Technical / News Bulletin

TB 0457

Product Group:	Manual Wheelchairs		
Model Affected:	Quickie Xenon Fixed Front and Quickie Xenon Swing-away		
Effective Date:	Immediate	Serial No. Effective From:	Implemented since February 2014
Bulletin Subject:	Change to upholstery coating

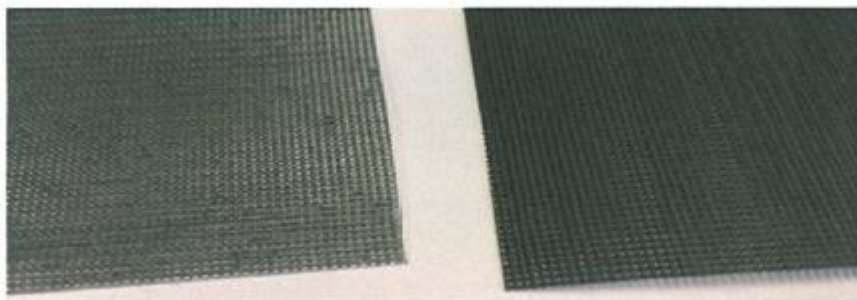
After a period in the field, and when subjected to direct sunlight or friction between the cushion and the upholstery, some upholsteries were becoming grey and fading

A more durable coating has been applied to the upholstery to prevent fading
